UNITED STATES  
DEPARTMENT OF THE INTERIOR  
BUREAU OF LAND MANAGEMENTFORM APPROVED  
OMB NO. 1004-0137  
Expires: January 31, 2018**SUNDRY NOTICES AND REPORTS ON WELLS**  
*Do not use this form for proposals to drill or to re-enter an abandoned well. Use form 3160-3 (APD) for such proposals.*5. Lease Serial No.  
NMNM121473

☐ Oil Well ☒ Gas Well ☐ Other2. Name of Operator  
CHEVRON U.S.A. INC. 4323Contact: DORIAN K. FUENTES  
E-Mail: djvo@chevron.com7. Name and No.  
HH SO 10 P3 23H9. API Well No.  
30-015-439323a. Address  
ATTN DORIAN K. FUENTES 6301 DEAUVILLE BLVD  
MIDLAND, TX 797063b. Phone No. (include area code)  
Ph: 432-687-763110. Field and Pool or Exploratory Area  
PURPLE SAGE; WOLFCAMP (GAS)

Chevron respectfully requests the ability to change the BOPE rating for the selected well from a 10M system to a 5M system. The max mud weight at 10500' for the pore pressures is a 13.0 ppg. The MASP under these assumptions will be 4788 psi. The attached documents reflect a 5M system BOPE rating and test pressures.

Diagram B

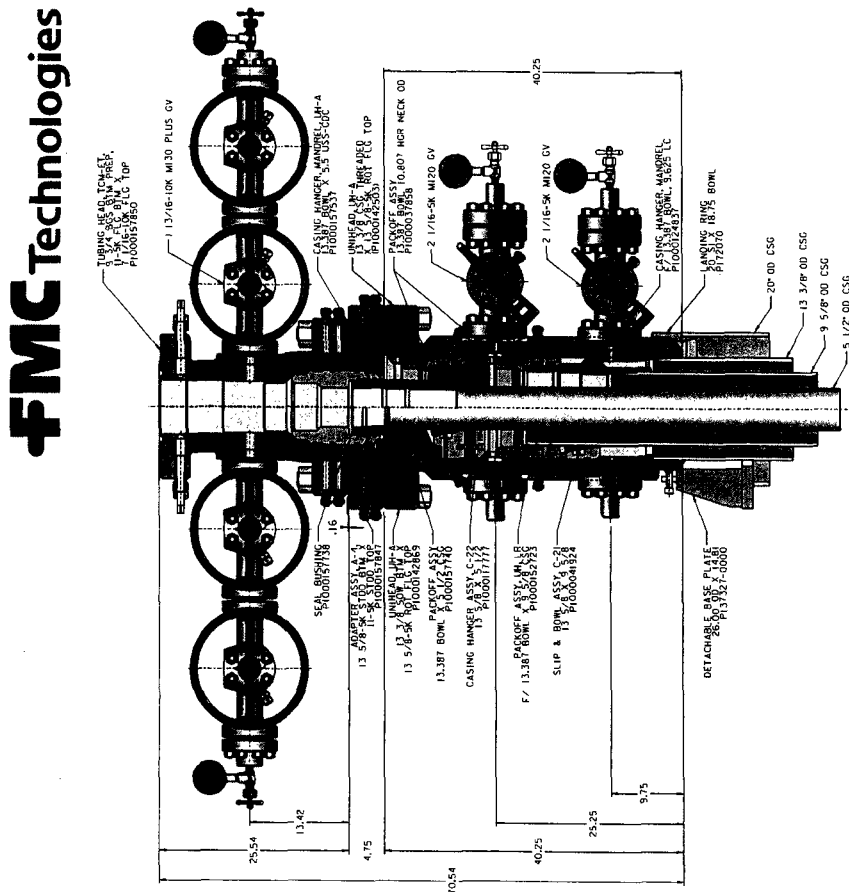
Chevron requests a variance to use a FMC Technologies UH-2 multibowl wellhead which will be run through the rig floor on surface casing. BOPE will be nipped up and tested after cementing surface casing. Subsequent test will be performed as needed, not to exceed 30 days. The field report from FMC Technologies and BOP test information will be provided in a subsequent report at the end of the well. Please refer to the attached wellhead schematic.

**Operator has proposed a multi-bowl wellhead assembly. This assembly will only be tested when installed on the surface casing. Minimum working pressure of the blowout preventer (BOP) and related equipment (BOPE) required for drilling below the surface casing shoe shall be 5000 (5M) psi.**

- a. Wellhead shall be installed by manufacturer's representatives, submit documentation with subsequent sundry.**
- b. If the welding is performed by a third party, the manufacturer's representative shall monitor the temperature to verify that it does not exceed the maximum temperature of the seal.**
- c. Manufacturer representative shall install the test plug for the initial BOP test.**
- d. Operator shall perform the intermediate casing integrity test to 70% of the casing burst. This will test the multi-bowl seals.**
- e. If the cement does not circulate and one inch operations would have been possible with a standard wellhead, the well head shall be cut off, cementing operations performed and another wellhead installed.**
